Product Change Notification (PCN)

PCN #: 80-2021

DATE: 8/27/2021

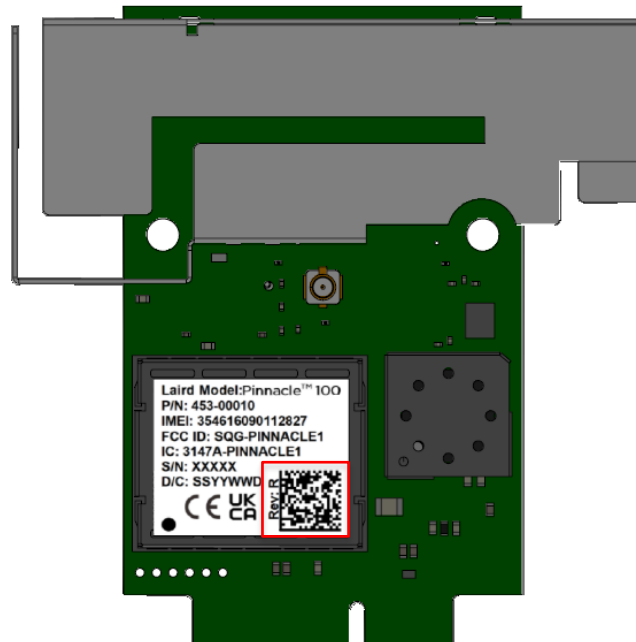
- Added UKCA certification logo to Pinnacle 100 modem module label.
- Added UKCA certification logo to back of MG100 gateway label.

5.3 Top Level Part Number Changes (Packaged Kits)

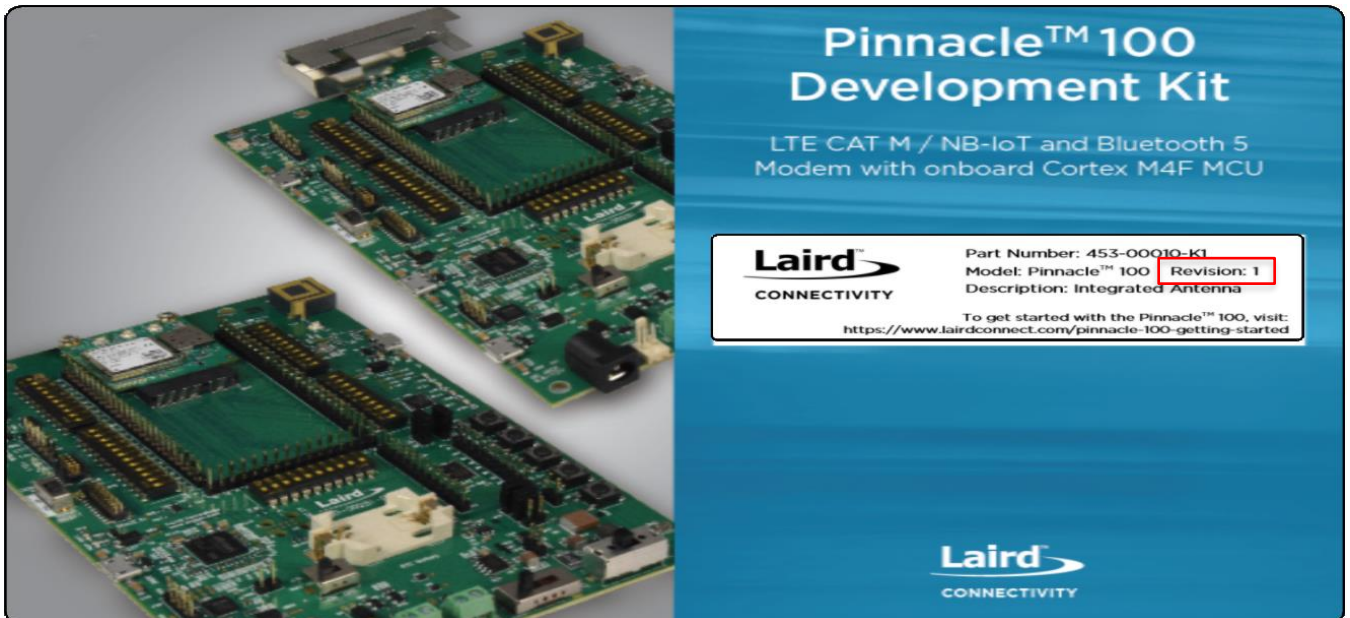
- The product revision level is defined as a revision number printed on the content label for all kits. The specific kit part number and revision can be found on the label within red square area, as highlighted below.
